IMPRESS FASHION LTD.

27 August 2015

Observations

Observations On DEA report of WASO Engineers & consultants (BD).

Overstressed Columns

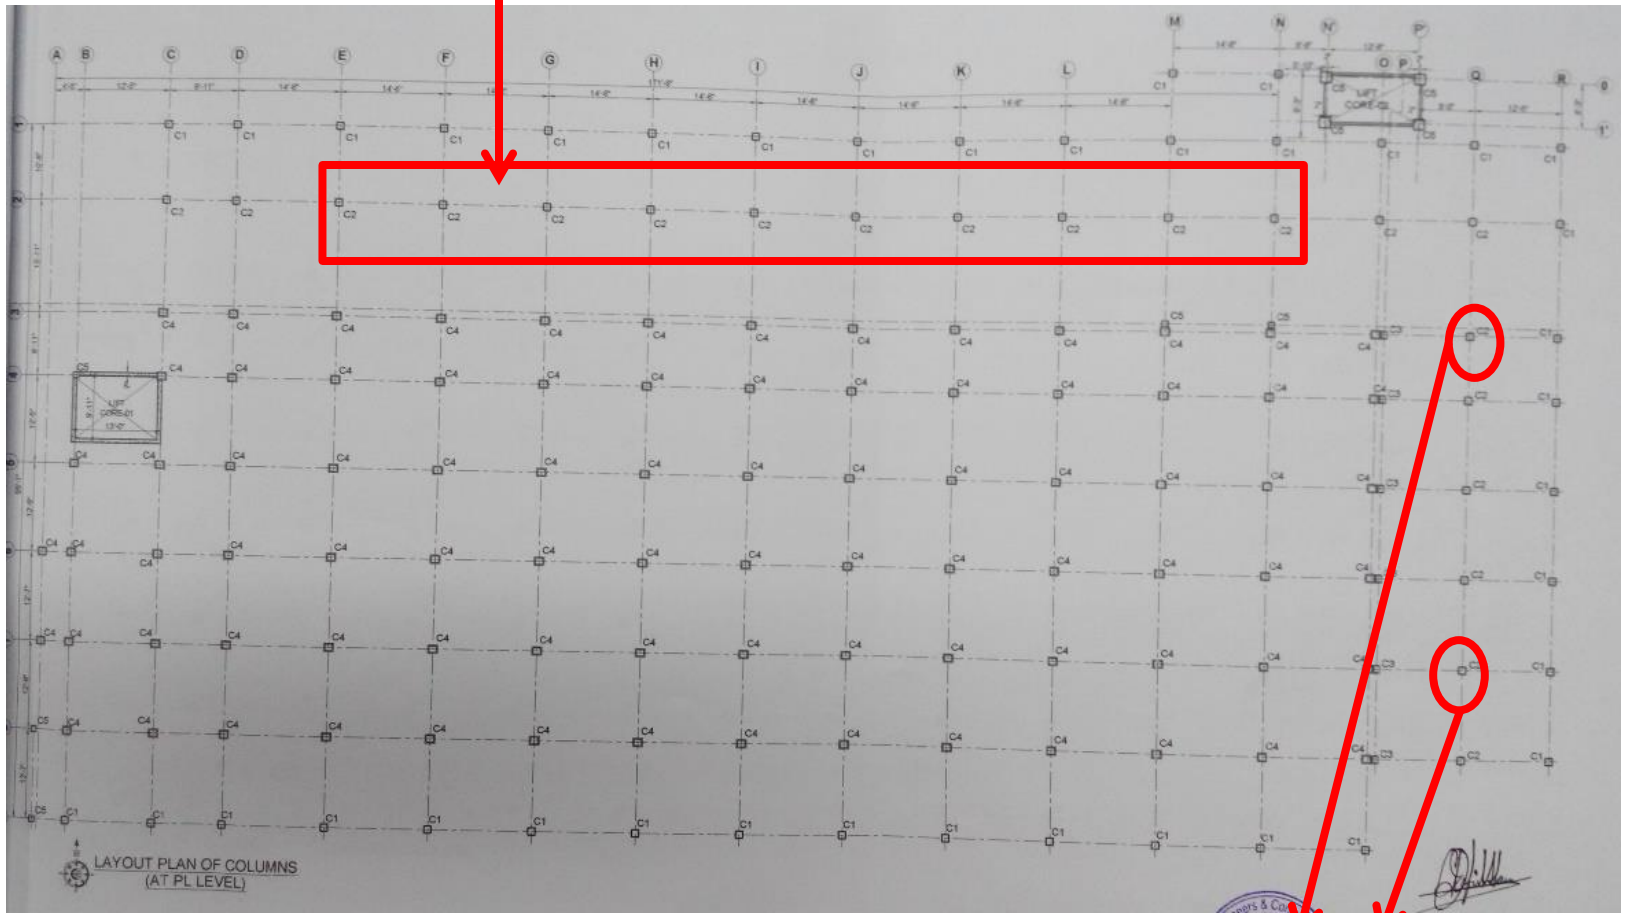
High stress on column.

Highly Overstressed columns

- Maintain 1 kPa load on this area (page 4) of all floors.
- Area shown on page 4 of 7th floor and roof cannot be used and cordon the construction work of toilet block before the revision of the detailed engineering assessment and maintain 1Kpa load on other floors.
- Verify insitu concrete stresses by considering existing core data and evaluate concrete strength using ACI code 562.
- Revise Detailed engineering assessment.

- Revise and actively manage a loading plan for all floors within the factory giving consideration to floor capacity and column capacity.
- Detail Engineering Assessment to be revised

- Continue to implement load plan
- Carry out remedial actions raised by Detail Engineering Assessment

Unusual foundation of shear wall

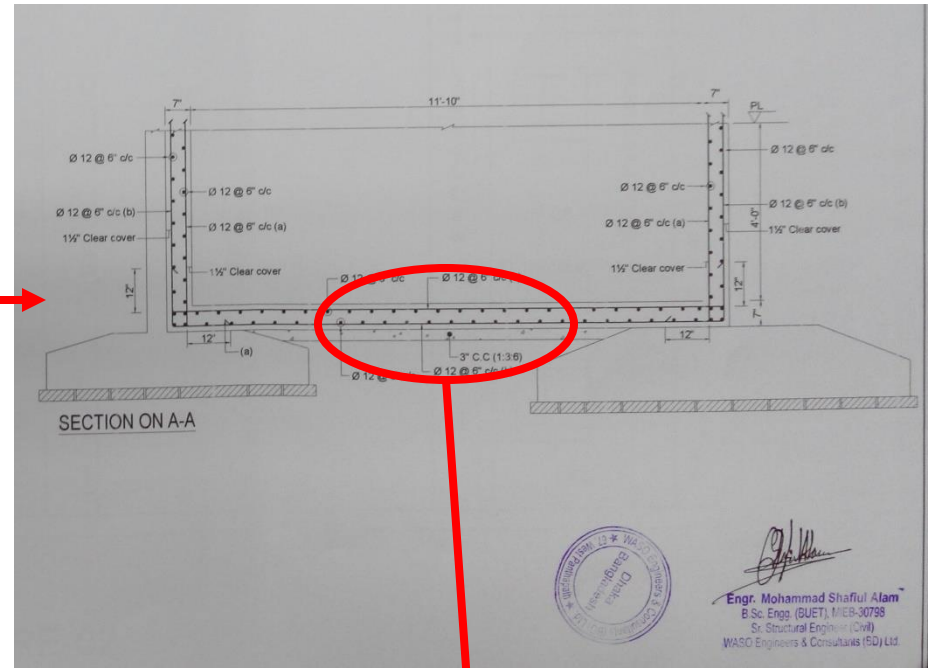
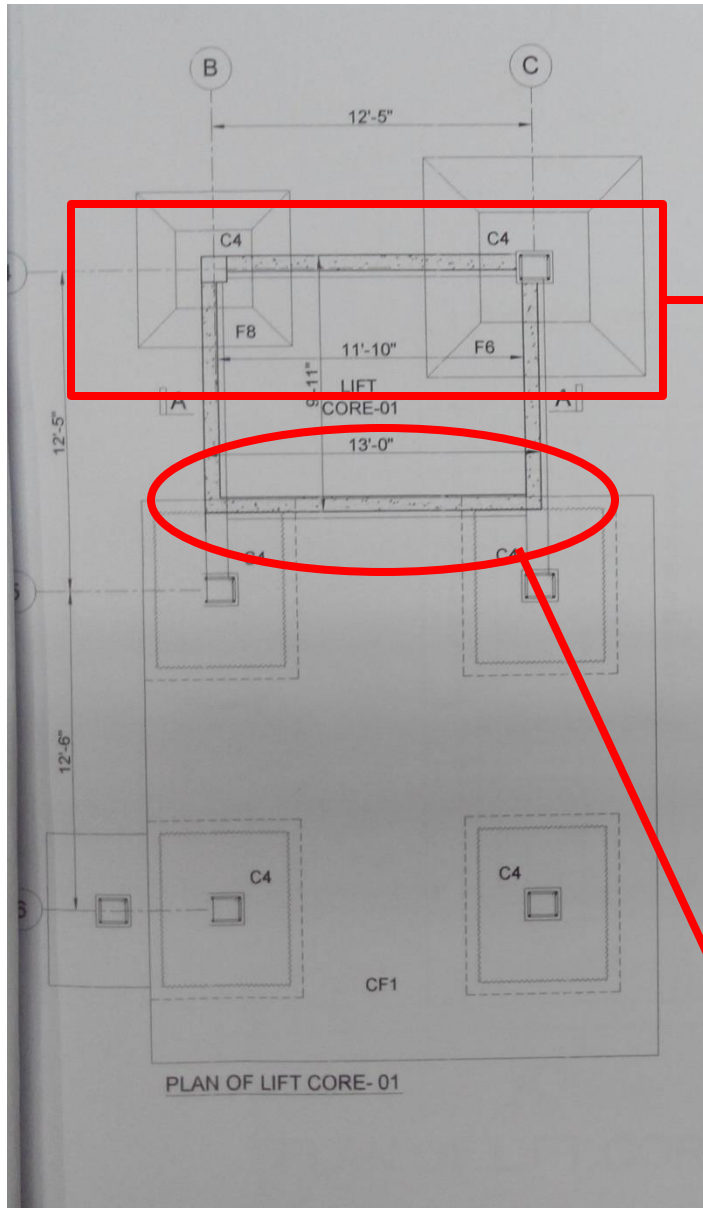
High stress on column

Support system is not clear

Foundation and load path is not clear.

- Investigate the foundation of shear wall.
- Revise Detail Engineering Assessment and check the foundation adequacy.

- Implement remedial actions raised or suggested by Detailed Engineering Assessment

Beam and column joint on 2nd floor

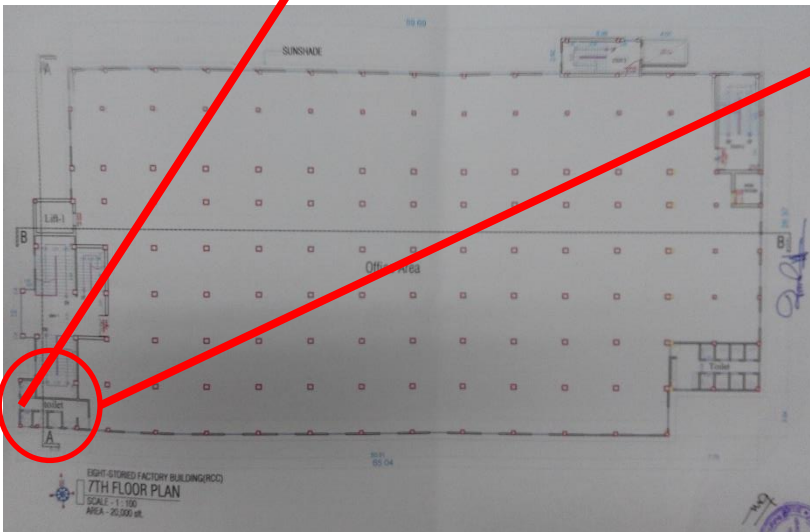
Connection of beams with columns and load path needs to be checked

- Check reinforcement details of those beams.(take pictures during investigation)
- Revise Detailed Engineering Assessment.

- Implement remedial actions raised or suggested by Detailed Engineering Assessment

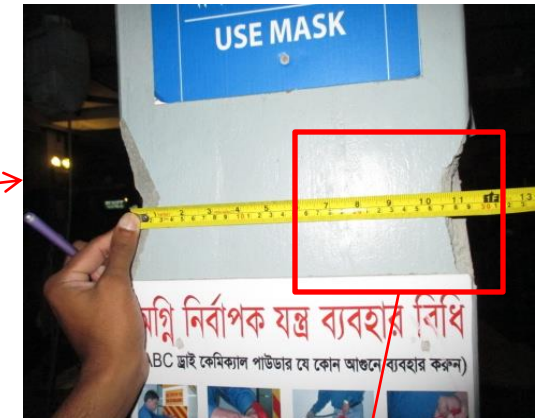
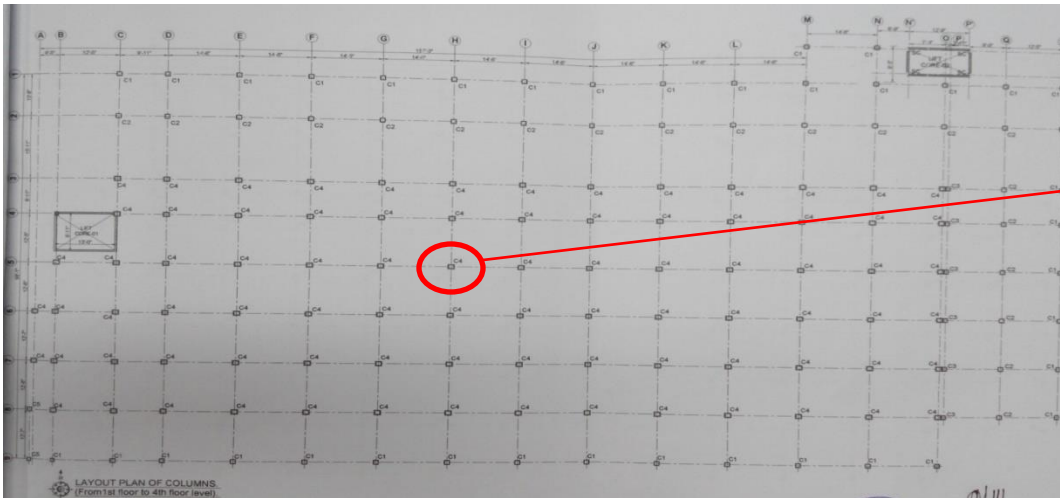
Architectural drawings of 7th floor plan don't match with actual situation.

- Update of As-built architectural and structural drawings.

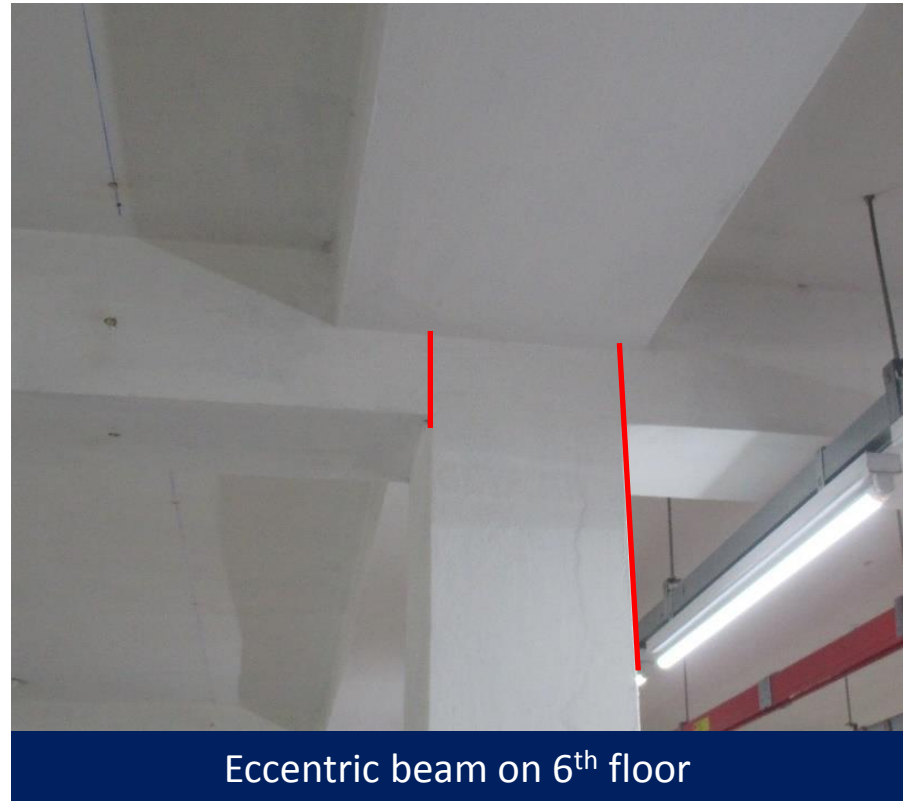
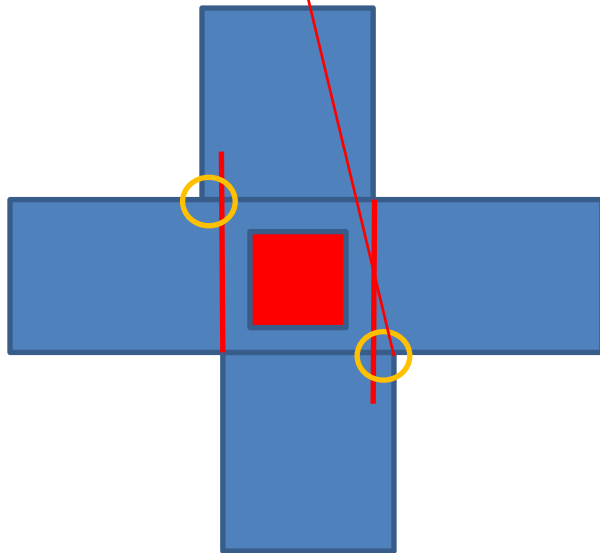
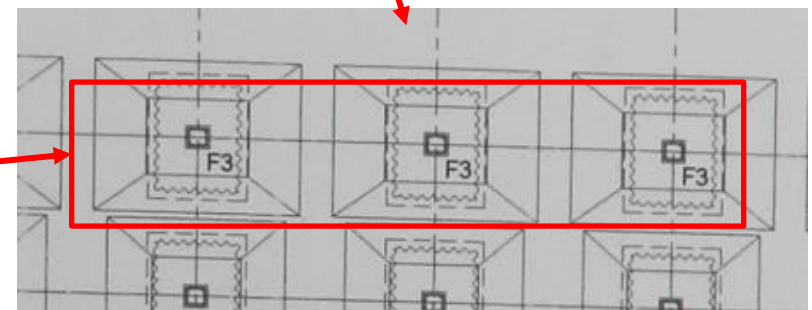
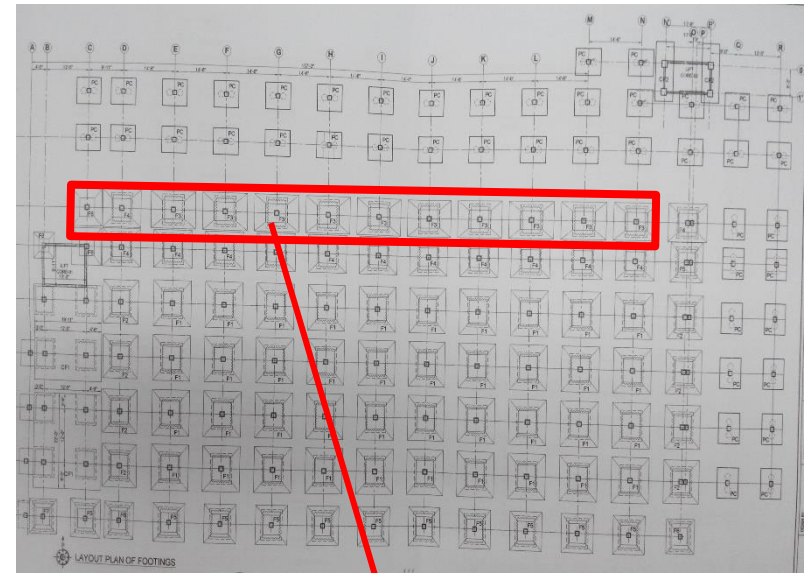
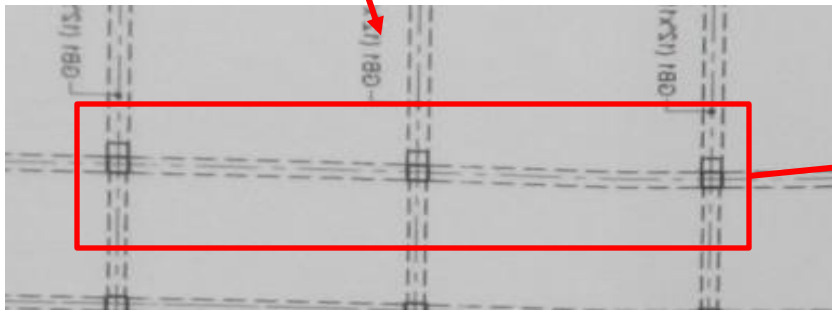
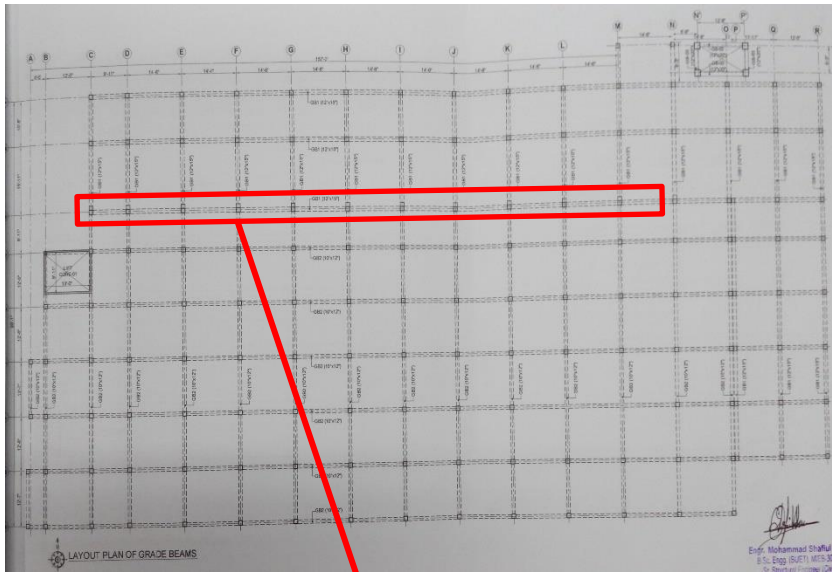
Size of some columns on site was found to be less than the that of the provided drawings.

Indicated column appears to be 11 inch without plaster where drawing states 12 inch.

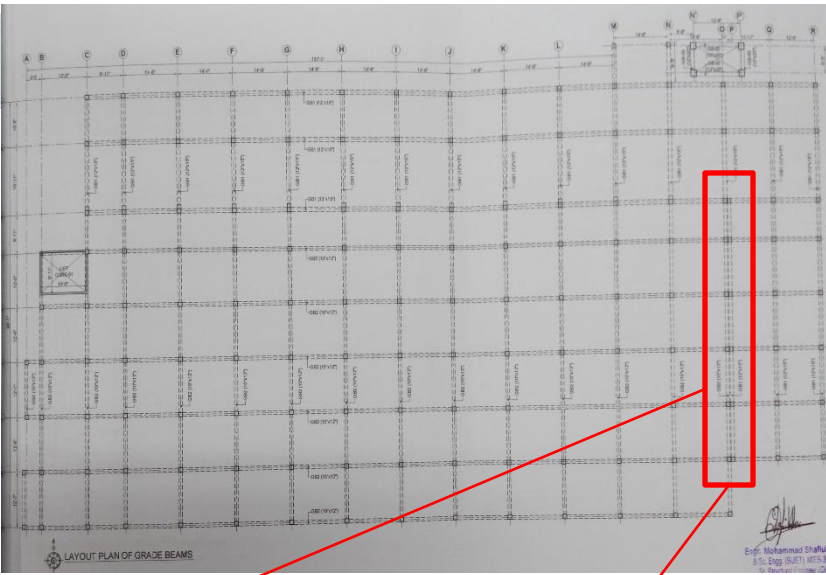
In layout plan of grade beam extra columns was shown on GL level in grid line 3, but in foundation layout it was shown as single column on isolated pad footing.

Layout plan of Column

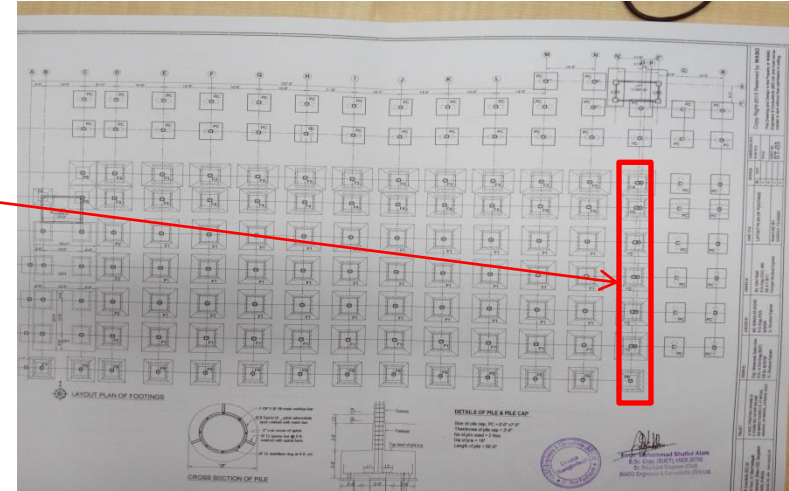
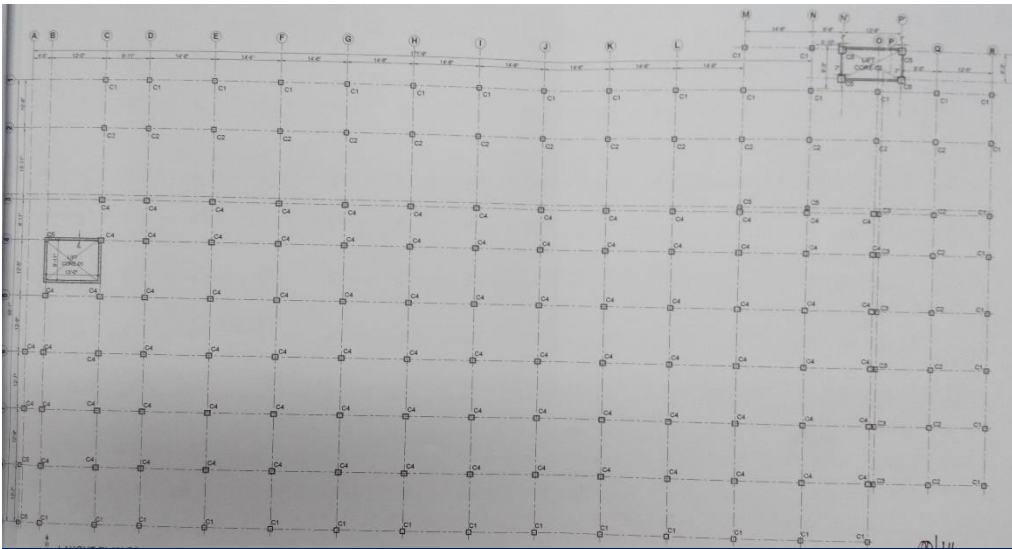
In drawing, in the Grid O & P, two columns exist with no gap between them upto 5th Floor. But the foundation section does not show foundation for two columns.

Column schedule

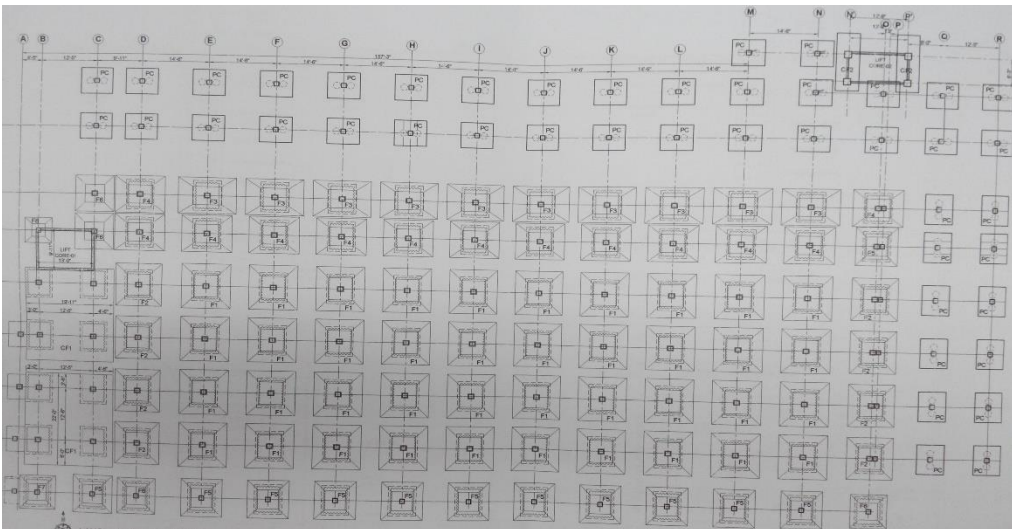
In column schedule column type C6 is shown as provided below PL but location was not shown on any drawings.

No water proofing was found on roof

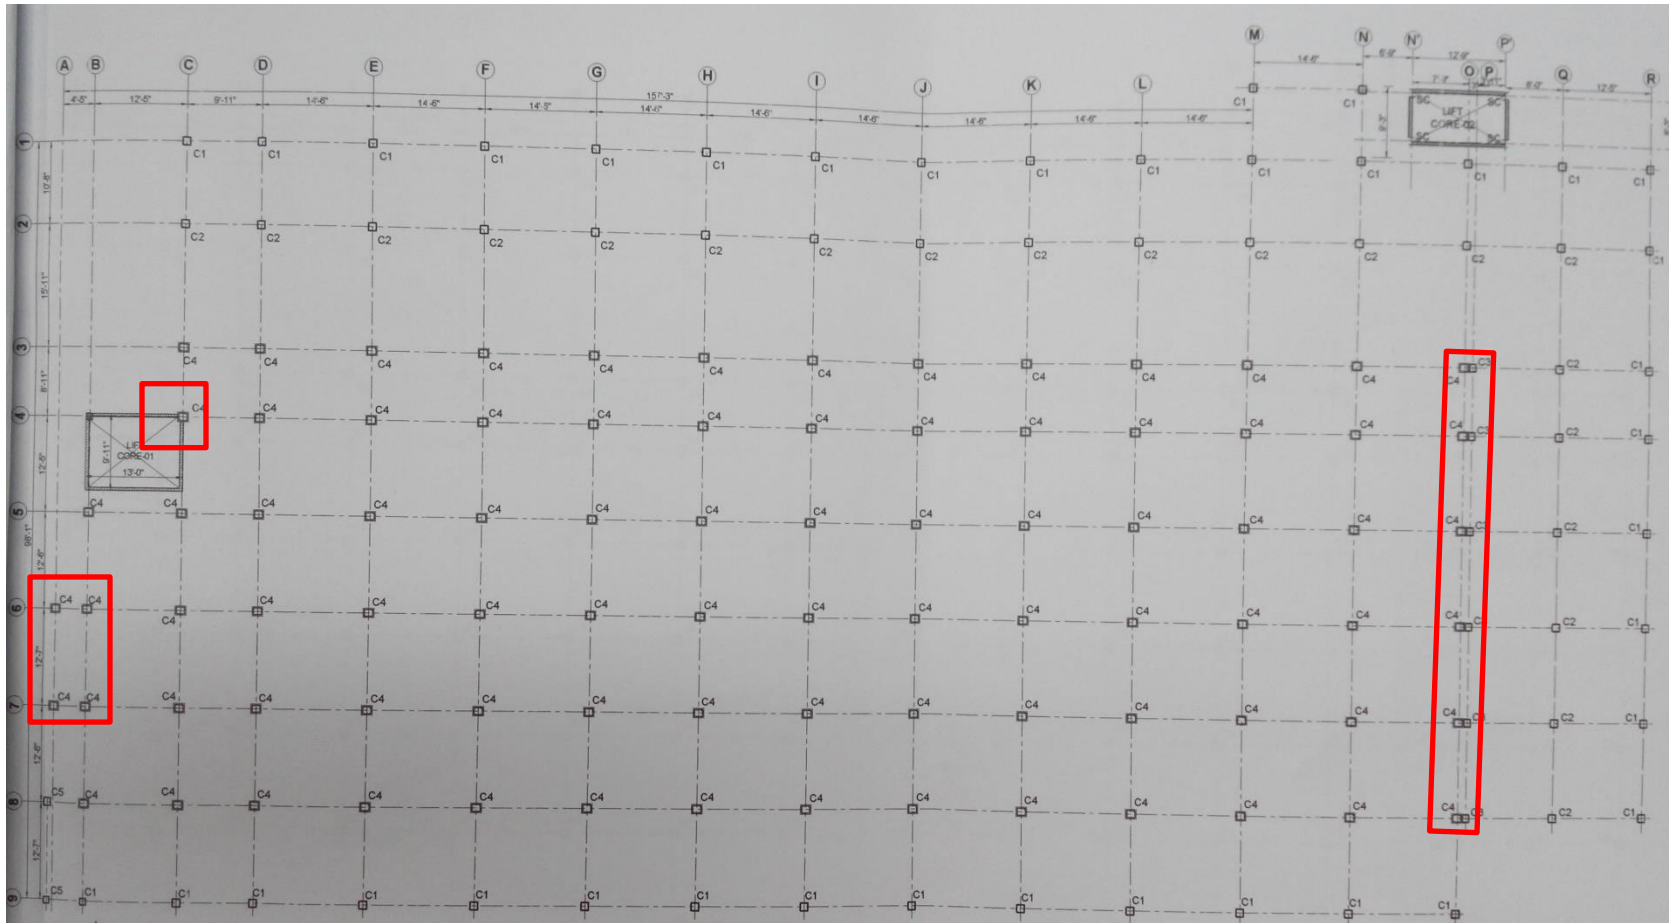
No water proofing membrane appears on roof.

- Provide water proofing layer considering the serviceability of the building.(should be done after completing all other remediation suggested in revised DEA)

Layout plan of column 1st to 3rd floor

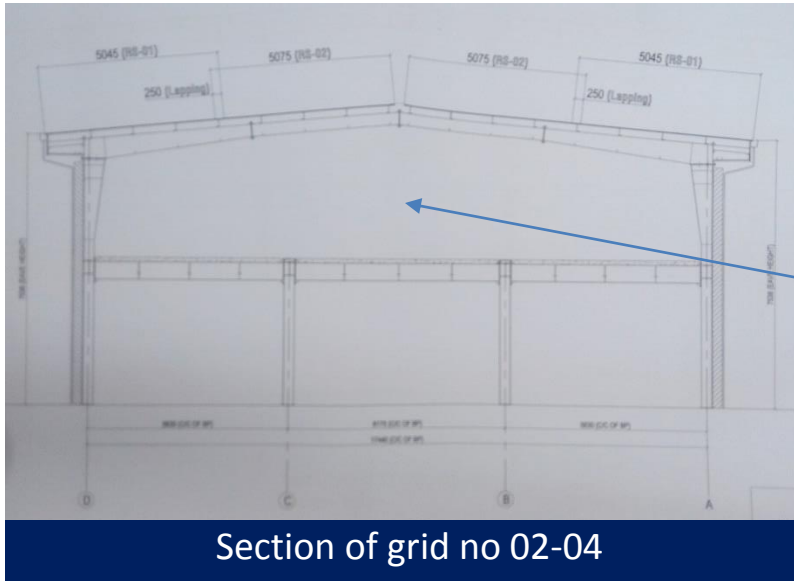
As per recommendations of “Sahidullah and new associates” all C4 columns needs to be retrofitted. But indicated(above drawing) C4 columns was not found retrofitted.

- Revise the DEA considering actual situation.

- Carry out the remedial measures of those columns if necessary or recommended by DEA after the acceptance of the revised DEA by ACCORD.
